UNITED STATES
NUCLEAR REGULATORY COMMISSION
WASHINGTON, D. C. 20555

Docket No. 50-244
LS05-81-05-016

SUBJECT: TMI-2 Category "A" Items

Amendment No. 42
License No. DPR-18

FIGURE 6.2-1

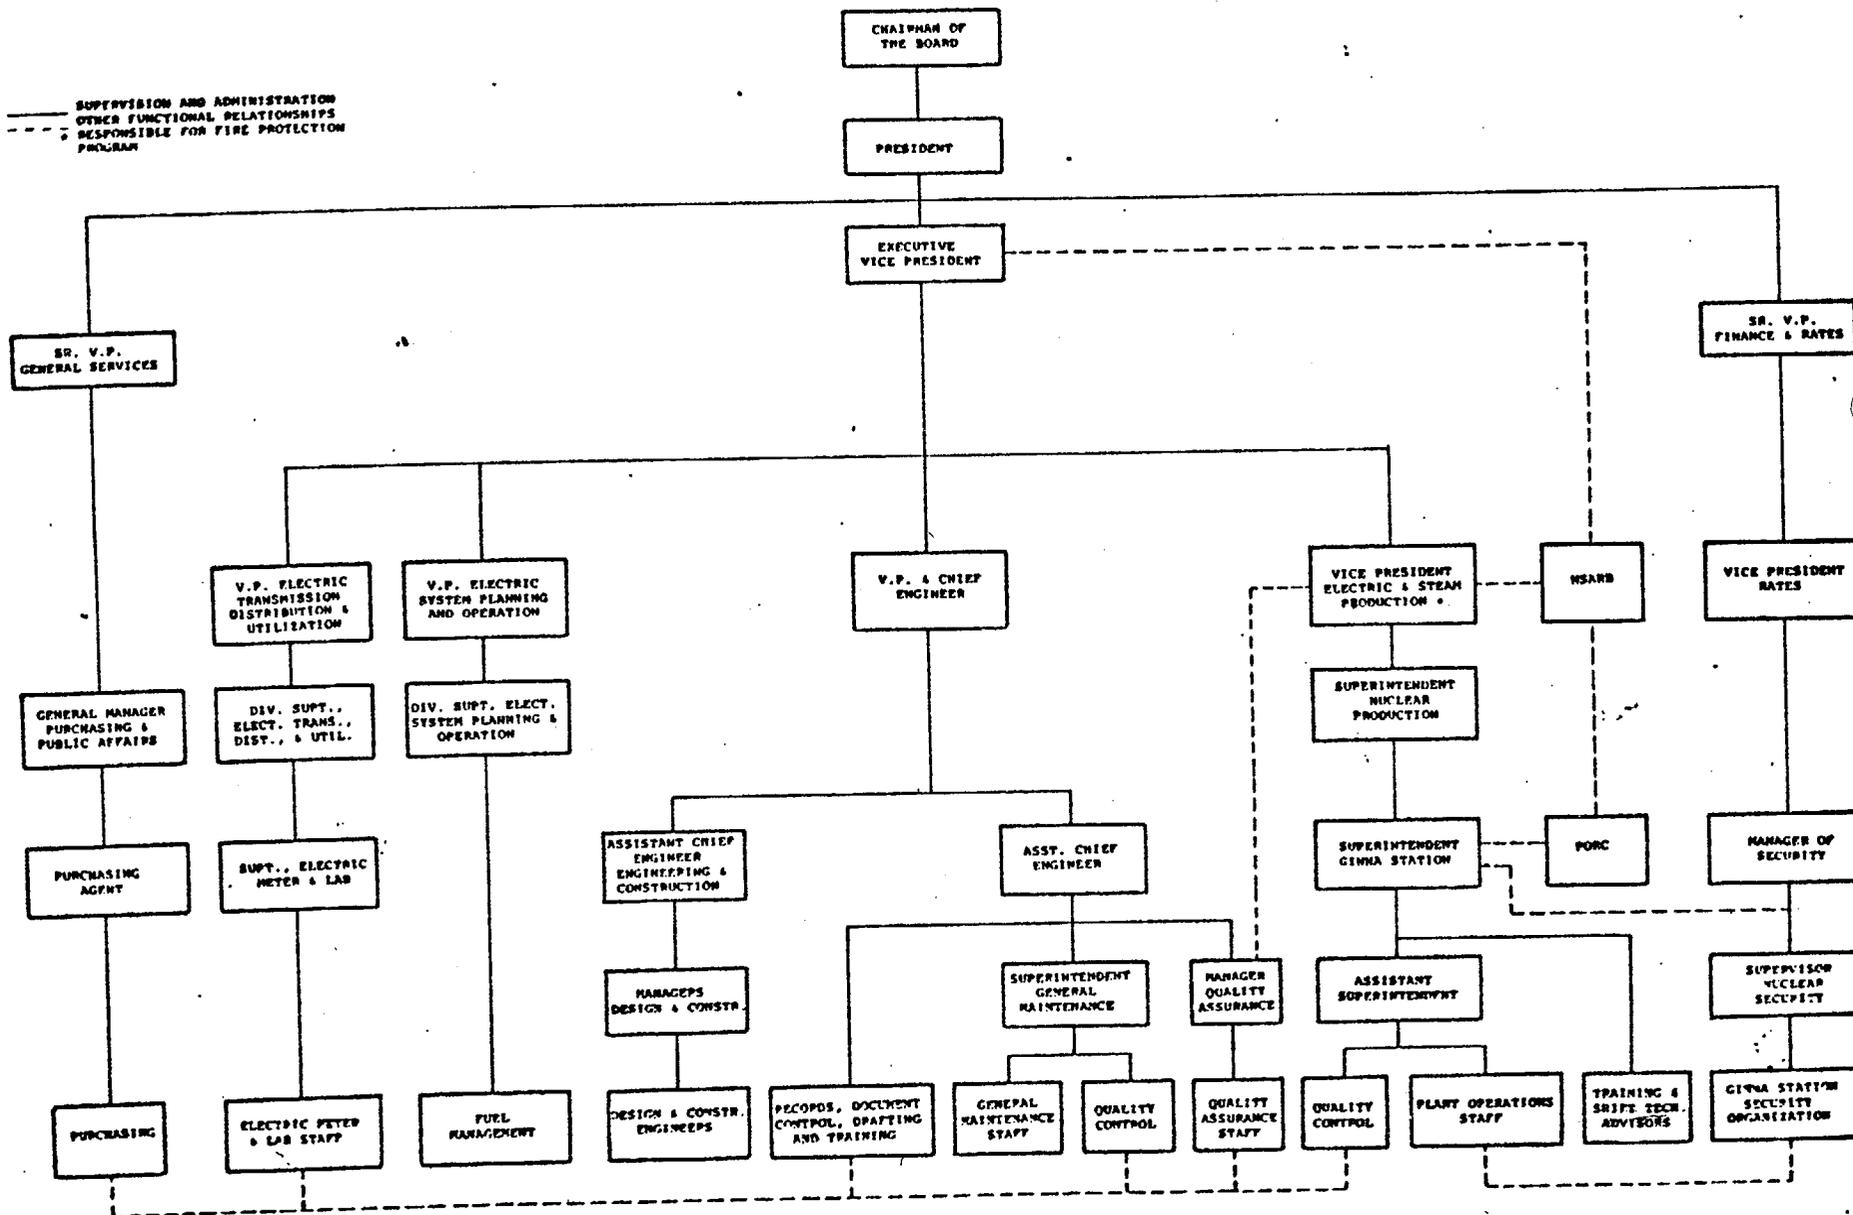
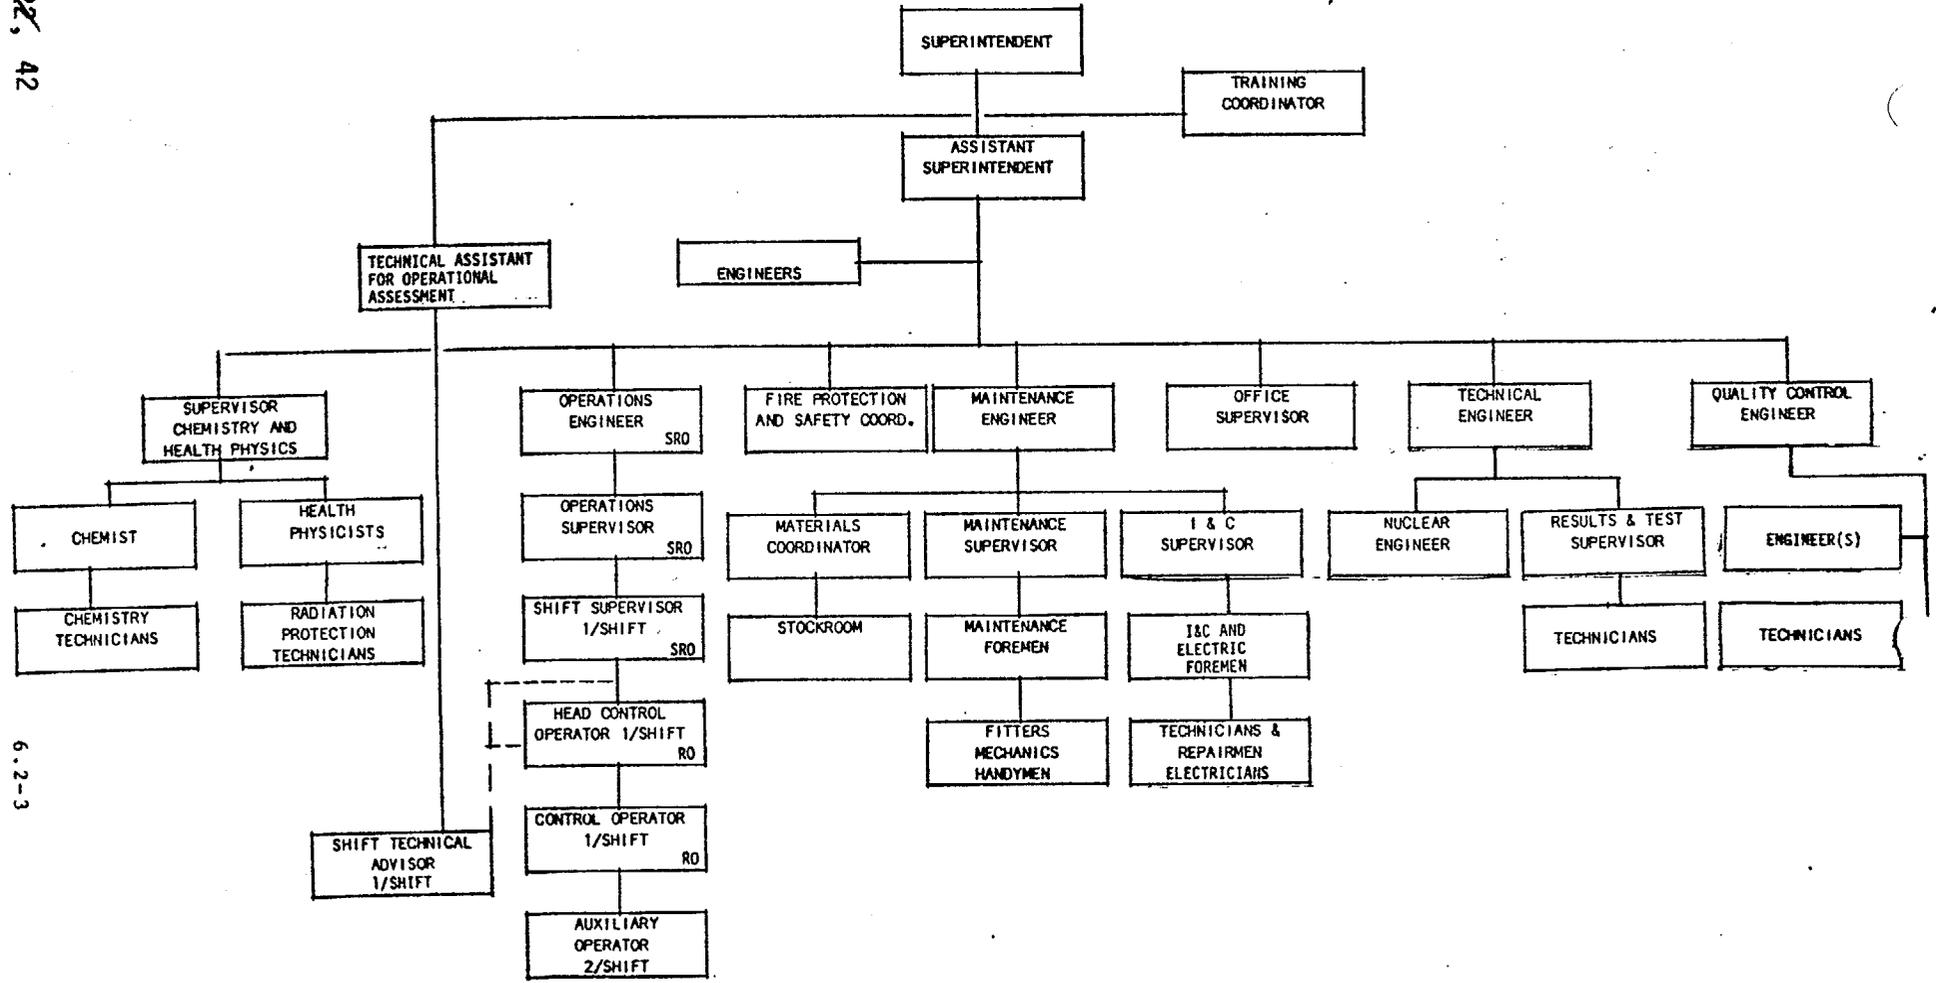
We have also included in this amendment changes to Technical Specification figures 6.2-1 and 6.2-2 regarding the Shift Technical Advisor and Technical Assistant for Operational Assessment in the Ginna organization. The change to Figure 6.2-1 was originally submitted by your application notarized

- (9) Changes to Figure 6.2-2 include those made to reflect the current Ginna Station organization and include the addition of an Office Supervisor, a Materials coordinator, and the plant stockroom. None of these changes are expected to have an impact on the safe operation of the plant and we therefore find them acceptable.
